XLamp® XP-E LED Product Change Notification

PCN Reference Number: CreeLED-PCN-5278
Date Issued: February 10, 2022

Figure 1 LED Forward Voltage vs Current Curves

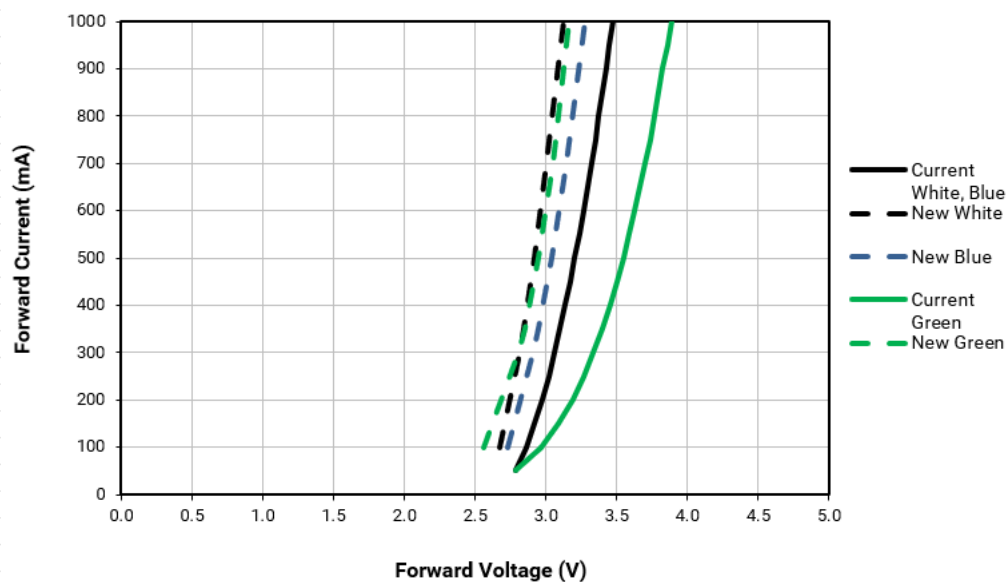
Cree LED will be changing the typical thermal resistance, typical and maximum forward voltage, and typical temperature coefficient of voltage characteristics for the affected XP-E LEDs. Table 2 shows the current and new values.

The following graph shows the improved Forward Voltage vs Current Curves.
